Product Change Notice

Issue Date: 8 Feb 2024

LED supplier change for Smart Display AllnGaP Deep Red devices

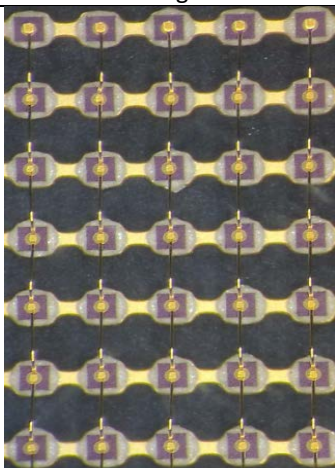
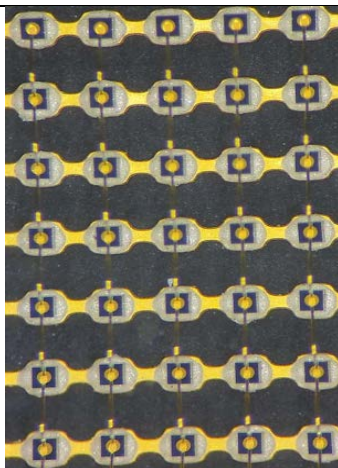
LED supplier change. No change to the product performance, except for the physical appearance and dimensions of the LEDs.

Existing LED	New LED
Appearance		
Dimension	9 mil x 9 mil x 7 mil	8 mil x 8 mil x 6.7 mil
